Peartree Hill Hydraulic Modelling Report (20-206-60-050-01)

Consultation Record

Meeting Title	Hydraulic Modelling Discussion
----------------------	--------------------------------

SECTION 42 OF THE PLANNING ACT 2008: CONSULTATION ON PROPOSED APPLICATION FOR DEVELOPMENT CONSENT.

Figure 1: Locations on the River Hull which intersect the red line boundary for the site where breaches are not proposed.

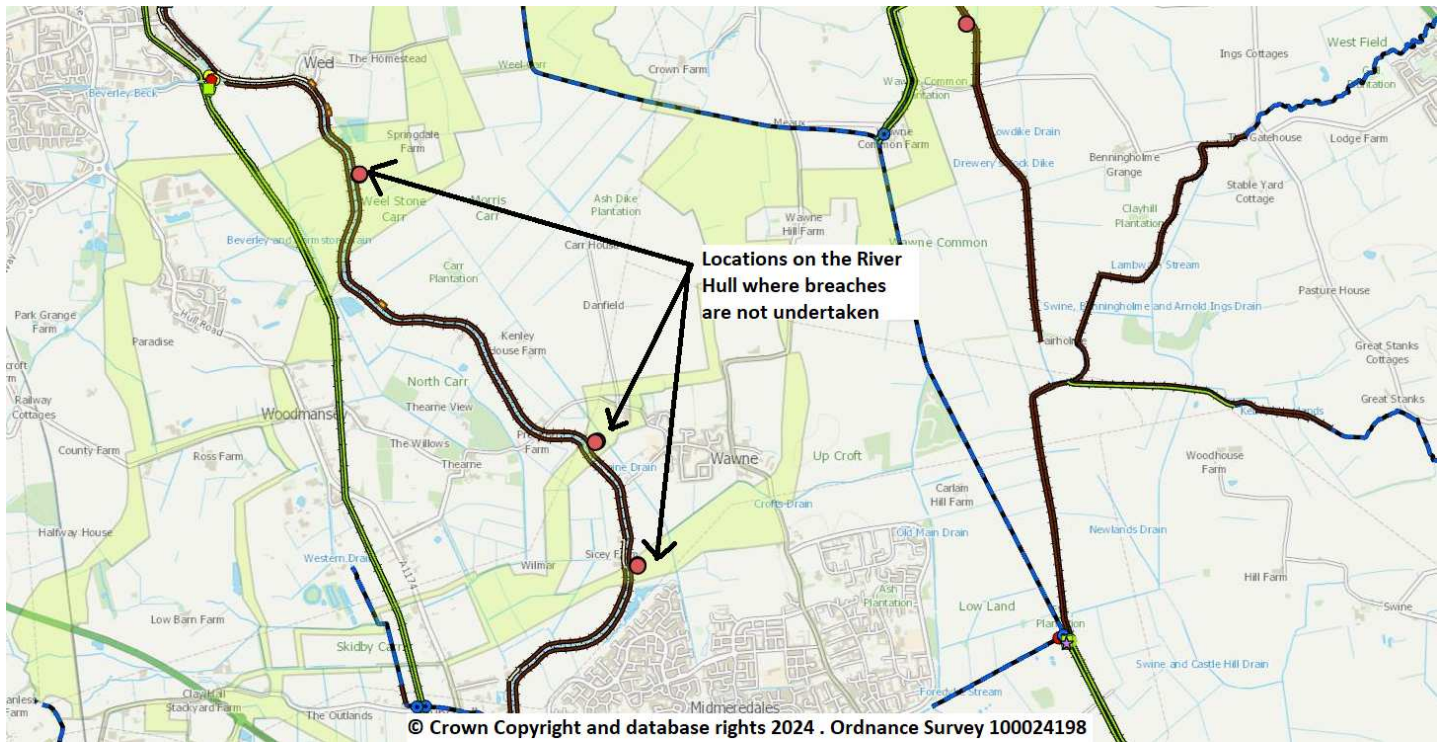
What was the rationale for not undertaking a breach at east 506700 north 438725, east 508280 north 436920, and east 508565 north 436090 on the left and right bank of the River Hull (figure 1 below)? Is this because these are relatively low risk areas for cable routing?
